Staff Report to the Agricultural Policy Advisory Commission

Application Number: **05-0084**

Project Description: Proposal to construct a single-family dwelling.

ZAHM RESIDENCE
 107-111-61
 APPL. # 05-0084

PARTIAL MAIN FLOOR PLAN

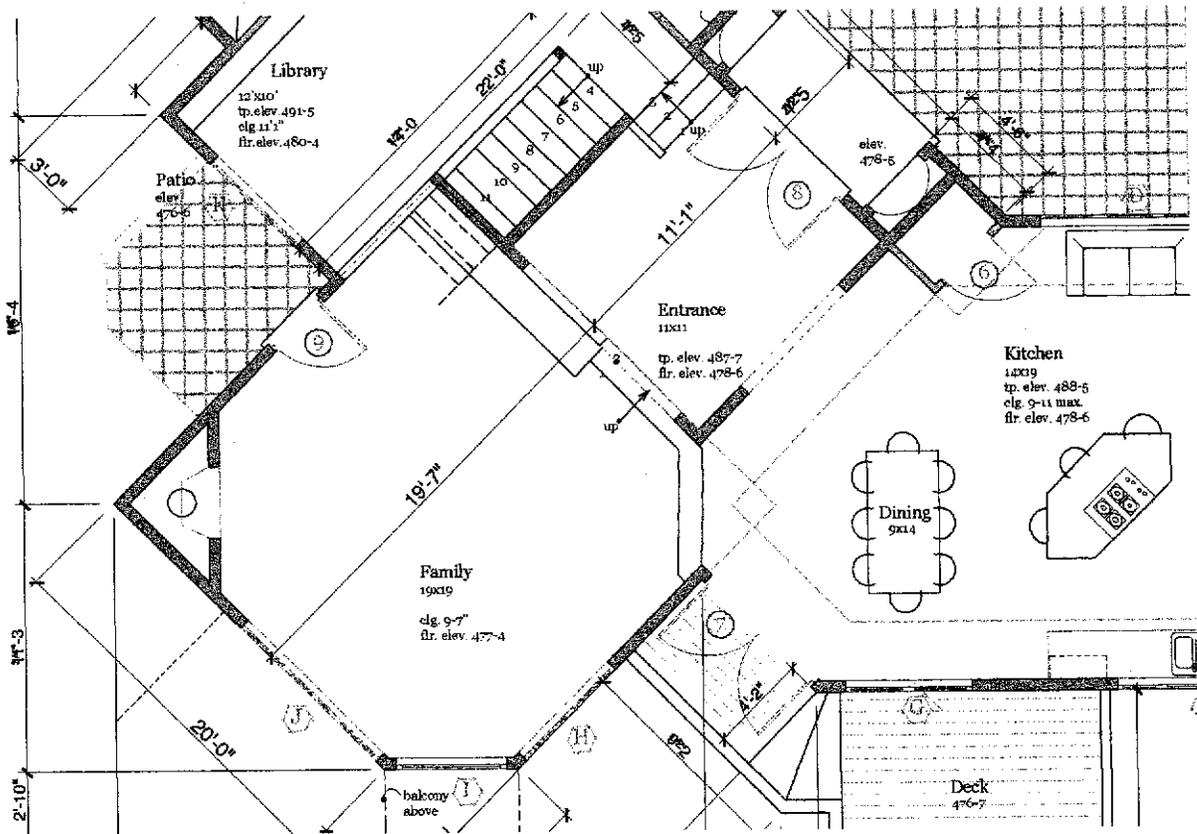
SHOWING CORRECTED PATIO OFF FAMILY ROOM

1. A portion of the patio is located outside of the building envelope. Any modification to the building envelope must be approved by the project geologist.

PARTIAL SITE PLAN

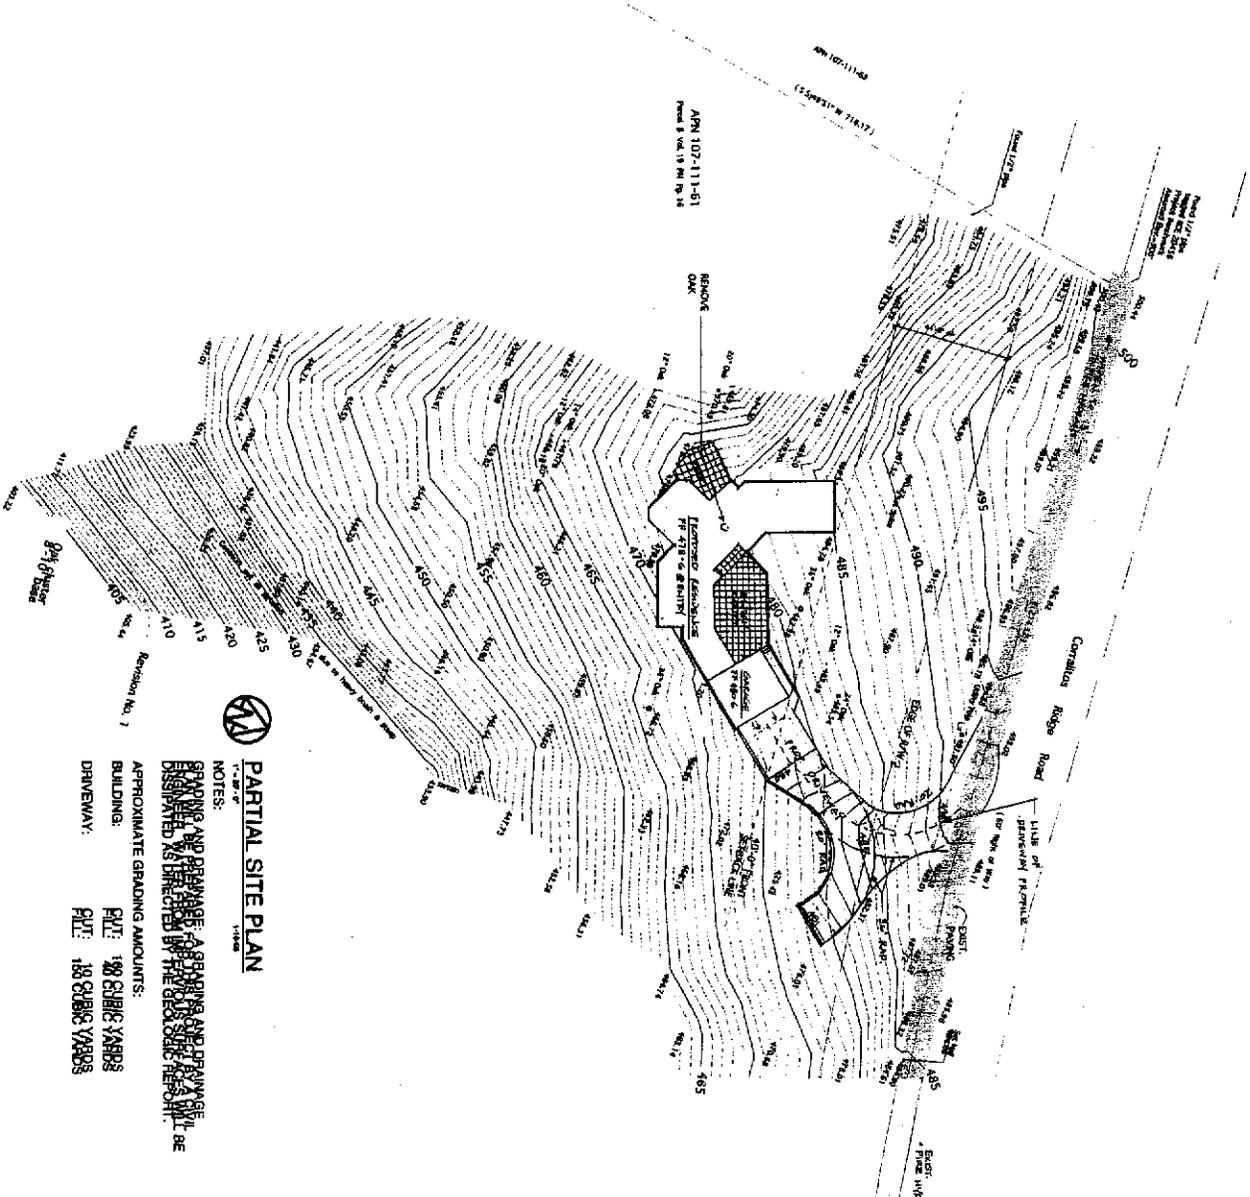
The PARTIAL **SITE PLAN** shows the homesite, driveway and septic leachfield locations along with the building envelope boundaries that were defined in our geologic report. The home is wholly within the boundaries of the building envelope. The septic leachfield is situated northeast of the building envelope, but this **is** acceptable from a geologic standpoint. We showed the leachfield location in our report, and the location shown on the plans adheres to that in our report. The leachfield is located on slopes of less **than** 30% gradient, and it is setback a sufficient distance **from** steep slopes below the site such that we are not concerned with slope instability in the leachfield area.

The plans show a driveway leading down from the access road above. The driveway location is also not within the designated building envelope, but this is acceptable since the driveway is located on gentle slopes, well away from any steep slopes. We could not designate the building envelope to include the driveway because the northern building envelope boundary was associated with a fault study, so we could not extend the building envelope to the northeast of the homesite **further** than shown on the plan sheet.

In regards to drainage around the homesite, we are of the opinion that drainage from impermeable surfaces should be dispersed as **much** as possible and be directed into the two natural drainage courses on either side of the ridge where the homesite is located. We cannot support discharge of runoff into the subsurface due to potential instability on the steep side slopes of the ridge. Drainage pipes should extend to near the axes of the drainage courses to reduce the introduction of concentrated runoff on the steep hillsides around the ridge. Both natural drainage courses near the homesite lead down to a very well established drainage course at the base of the south-facing hillsides on and below the property. Natural runoff from the property has flowed in these two drainage courses to the larger drainage course at the base of the hillside for hundreds of years, if not more. We are aware of very permeable earth materials at the base of the hillside where abundant recharge will not likely take place, even during periods of high flow during winter rainstorms.
